**MEETING OF THE DESIGN REVIEW BOARD
MORRIS N. BROAD COMMUNITY CENTER
1175 95TH STREET
BAY HARBOR ISLANDS, FL 33154**

REVISION # 1 REVISION DATE: 07/18/23

Subject: Site Development Plan Application - Revision
Proposed New 9 DU Multifamily Residential Complex
Revisions to Approved Site Development Plan
1055 93rd Street
Bay Harbor Islands Acct. No. SPR22-000026
MMPA Acct. No. 01-0702-1144

Revision to Approved Planning and Zoning Board Submission

Sheet A-23, Exterior Elevation - EAST

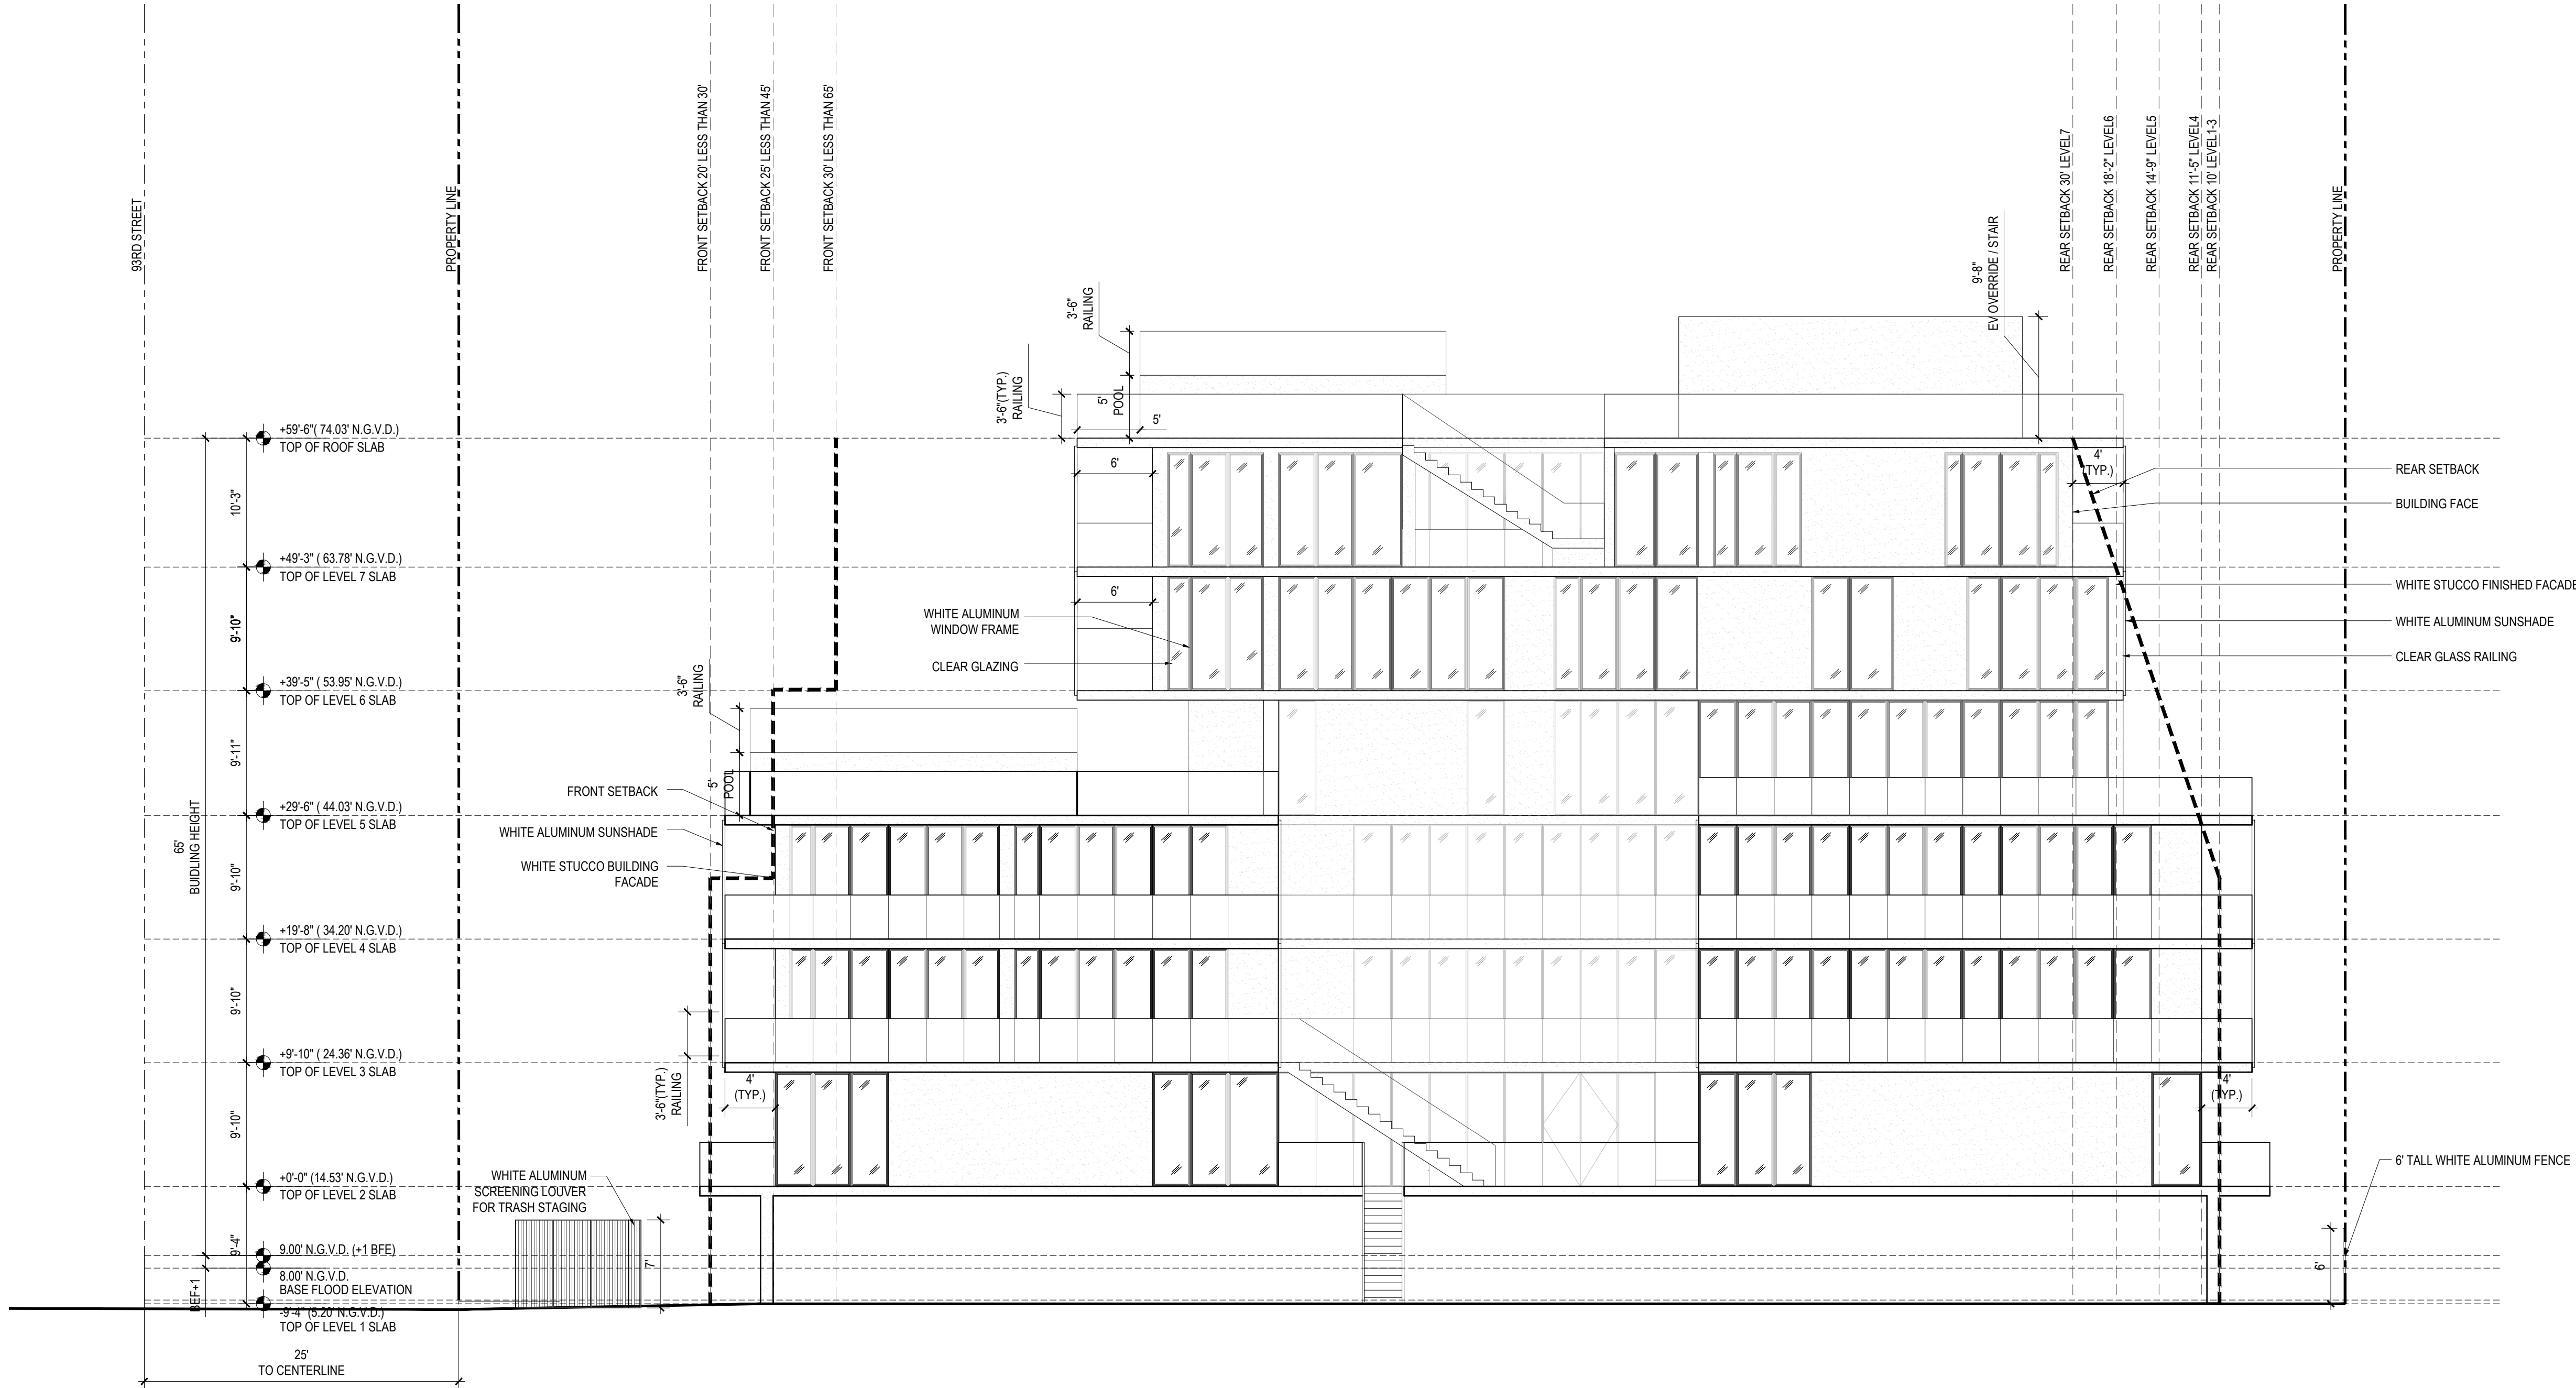
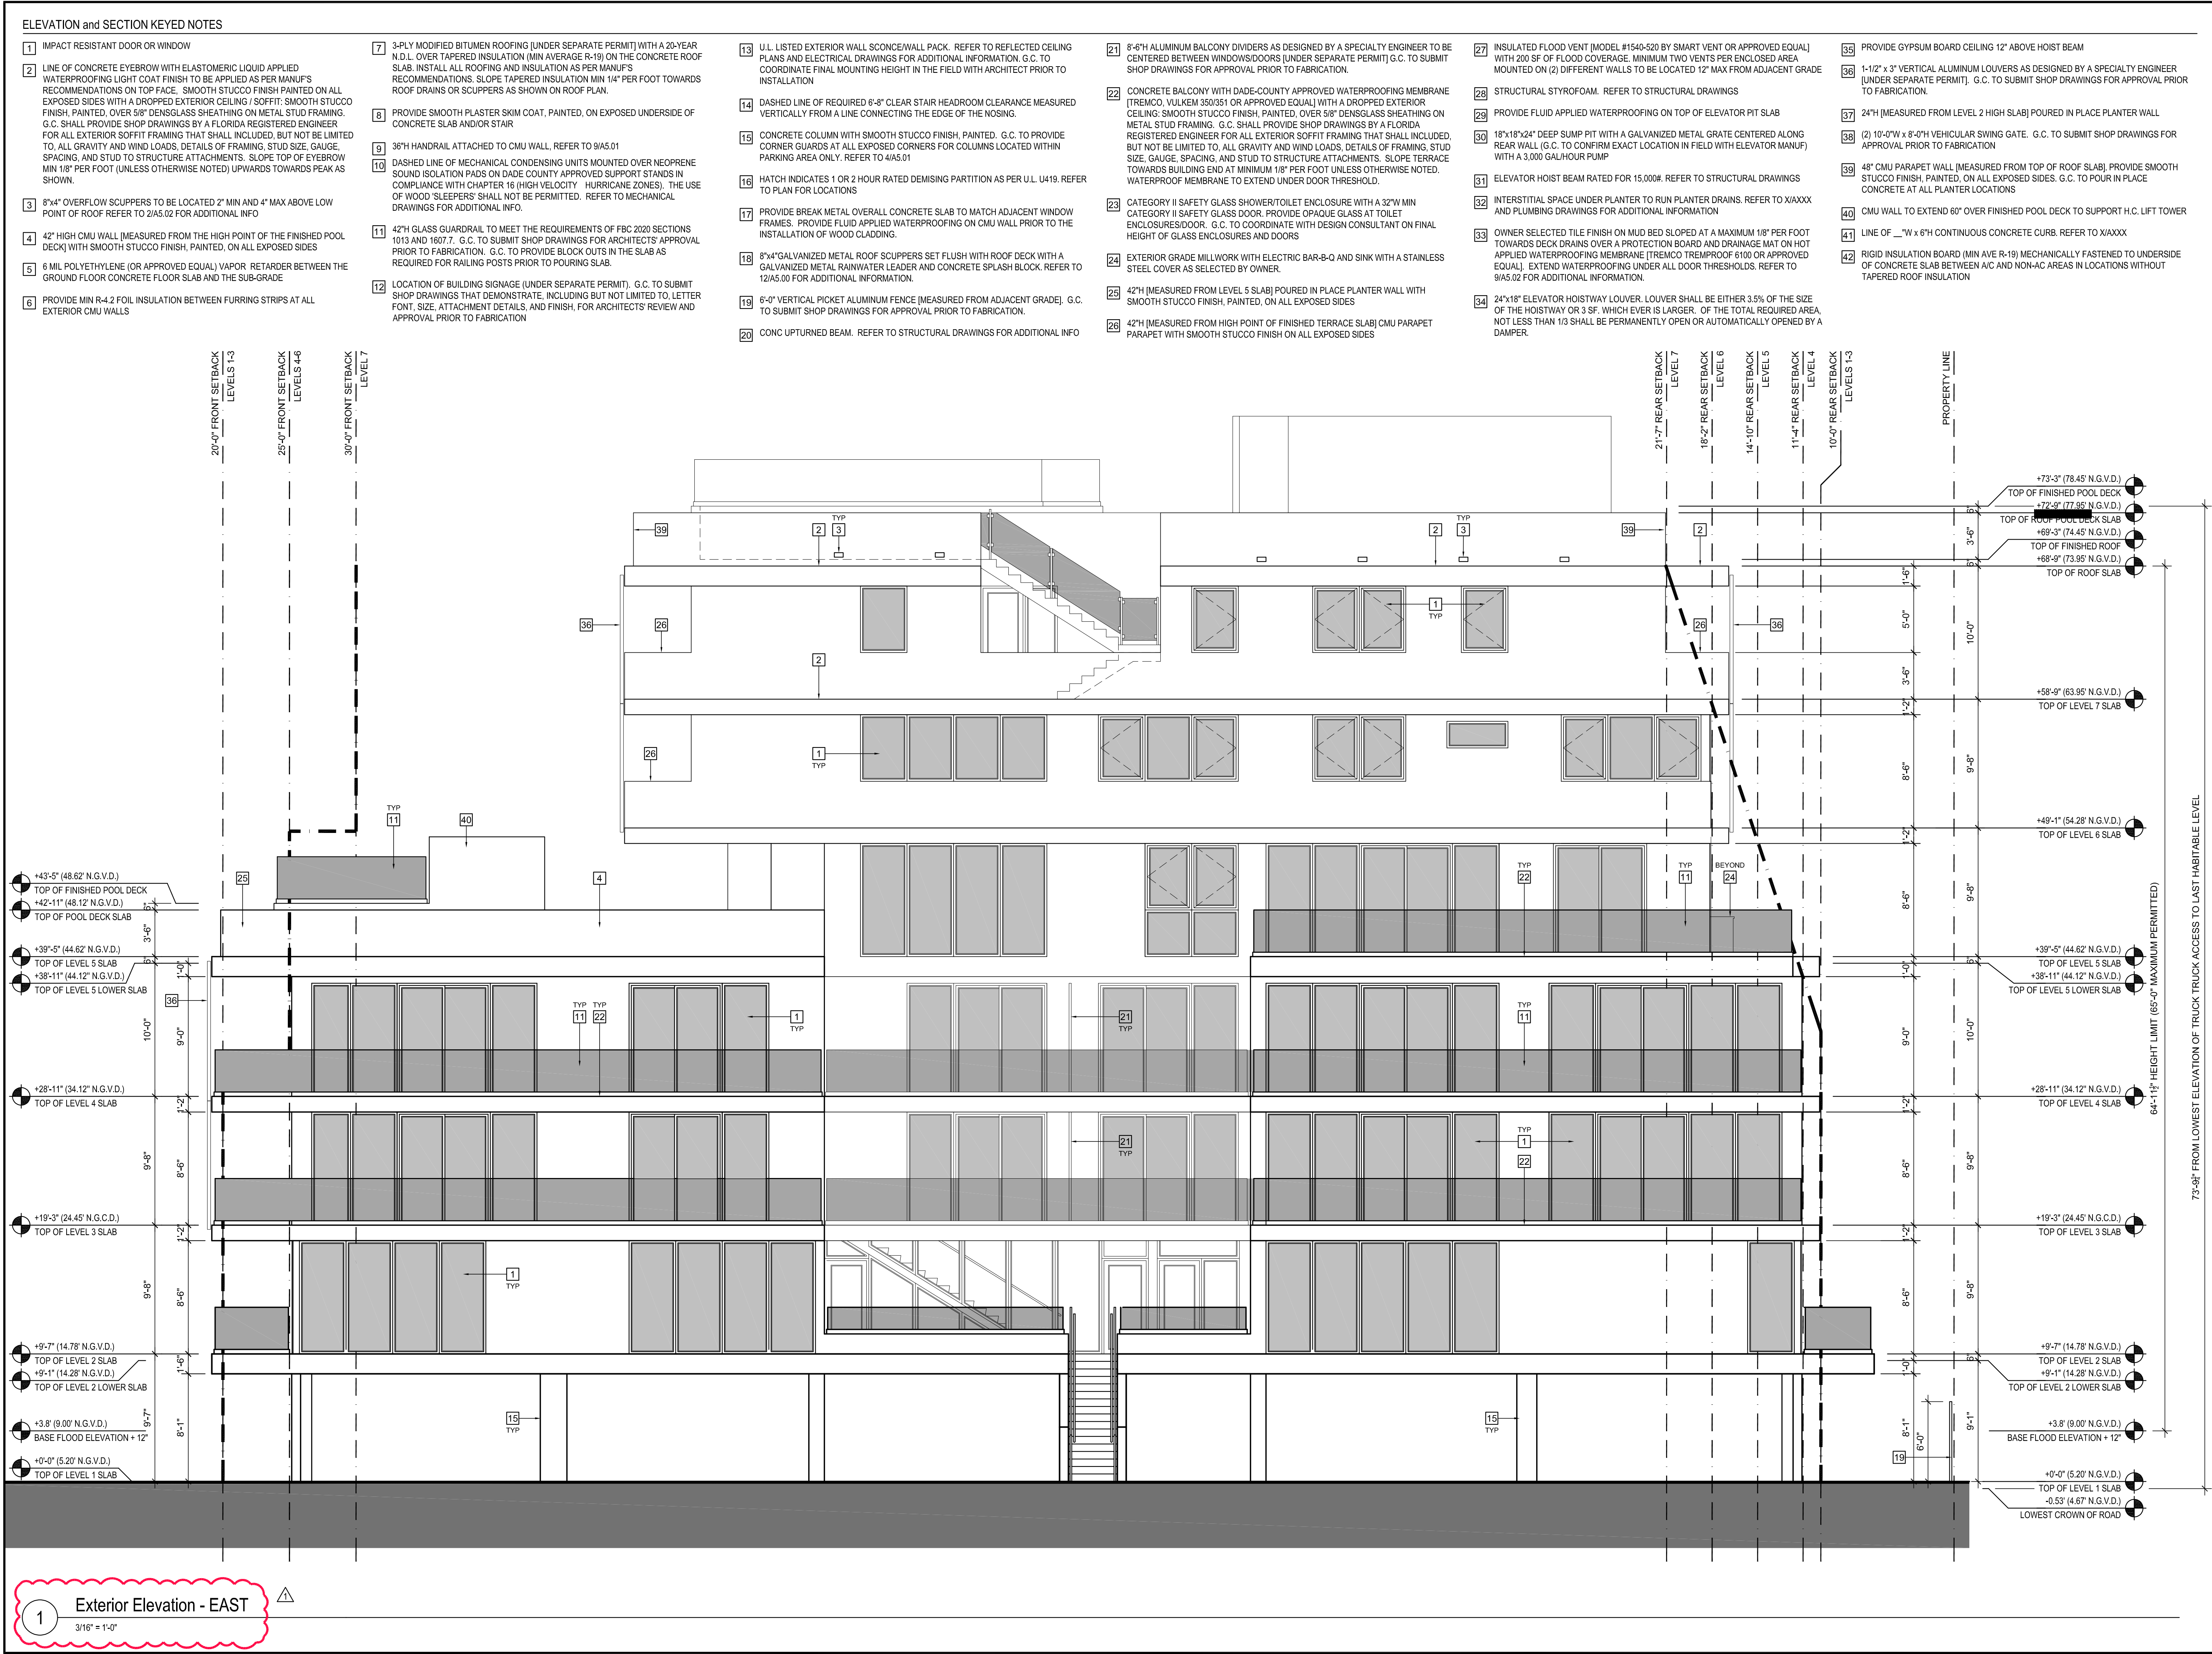
1. Modifications to the East Elevation to remove the north facing balconies and associated louvers on Levels 3 and 4 and to reduce the balcony on Level 5 due to the proximity to the FPL power lines that are running along the rear property line
2. Modifications to the design Level 2 Exterior Terrace in order to meet Miami-Dade Fire Egress requirements
3. Modifications to the exterior window/door placements and sizes due to changes to the unit layouts and coordination with Structural
